1978 - 1980 Corvette: Service Bulletin: Instrument Cluster Area Squeak

Subject: Instrument Cluster Area Squeak

Bulletin No: 80-T-37

Date: May, 1980

CORVETTE INSTRUMENT CLUSTER LENS
LOCATING TABS

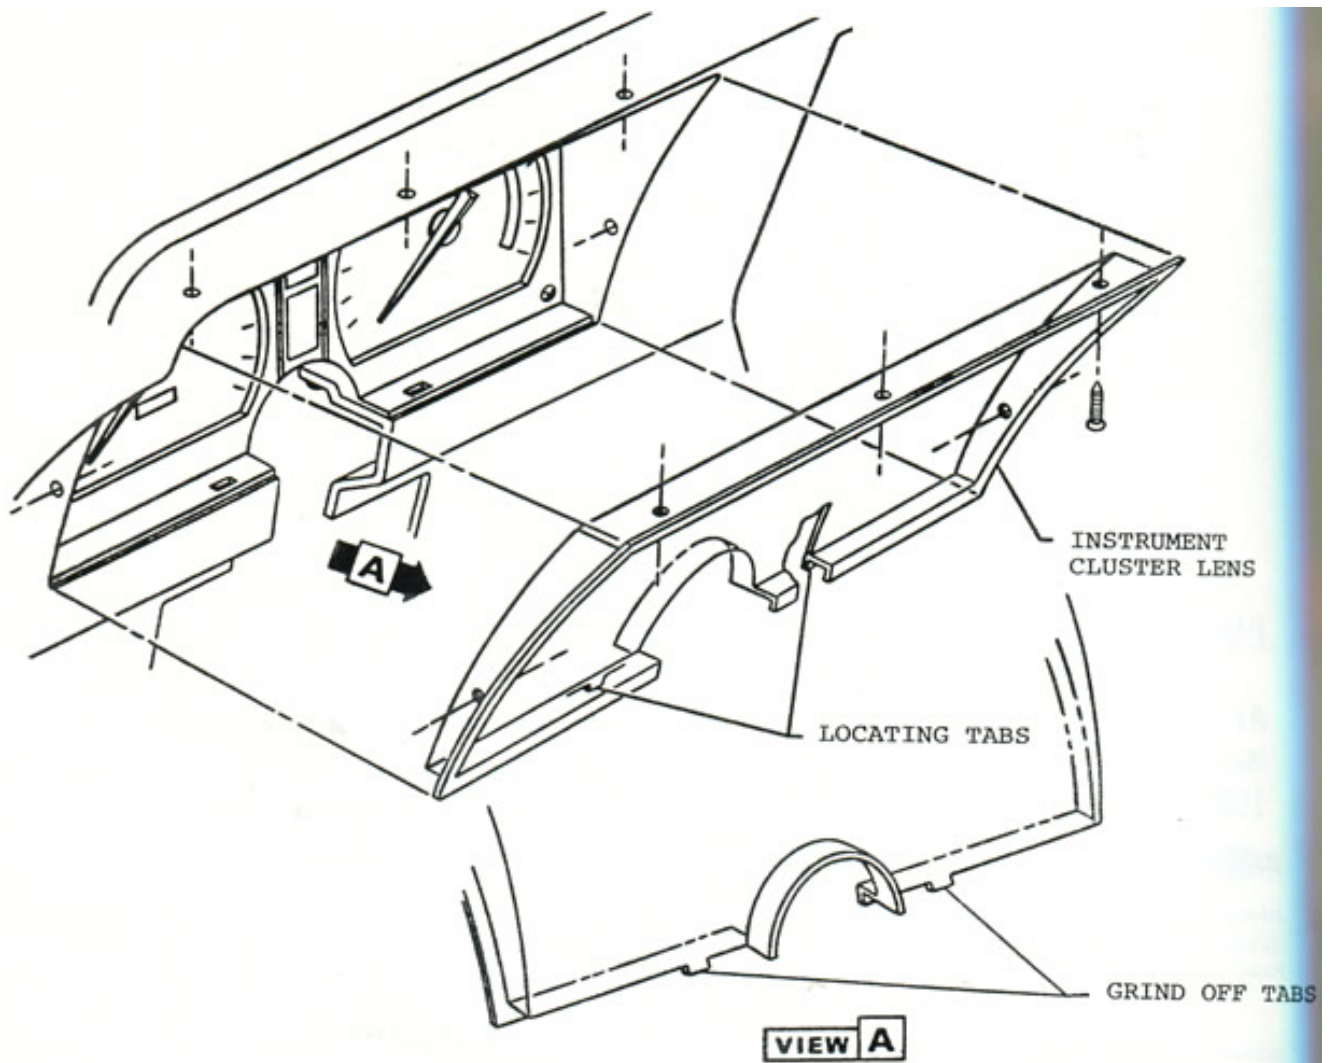
Light squeak emanating from instrument cluster area.

Lower tabs on cluster lens may rub against side of case locating holes. To verify this source, apply light hand pressure to lens.

Tabs will be removed from lens effective May 15, 1980.

1. Remove five (5) lens to case attaching screws and remove lens.
2. Grind off and file to a smooth surface the two (2) plastic locating tabs at bottom of lens, as illustrated on Page 2. CAUTION : The plastic lens is brittle and may crack if the tabs are snapped off rather than ground.
3. Reinstall lens to case with five (5) screws.
